**Plans Preparation Manual  
January 1, 2008 Updates**

Robert Quigley, P.E.  
Roadway Design Office  
Criteria and Standards Section  
850-414-4356  
robert.quigley@dot.state.fl.us

- Section 8.3.2 Disability Considerations

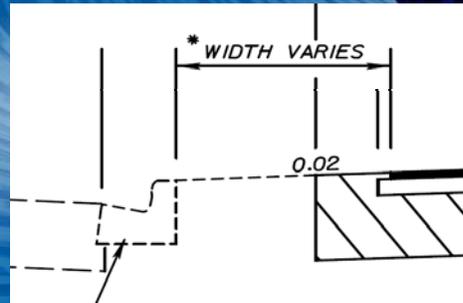
- ◆ Revised to provide guidance for the application of detectable warning systems for an asphalt surface
  - Use system that works with asphalt
  - Use short section of concrete that can accommodate any system
- ◆ Clarification that ADA requirements apply to pedestrian crossings
  - Grade
  - Cross slope
- ◆ Corresponding changes in Section 8.3.3
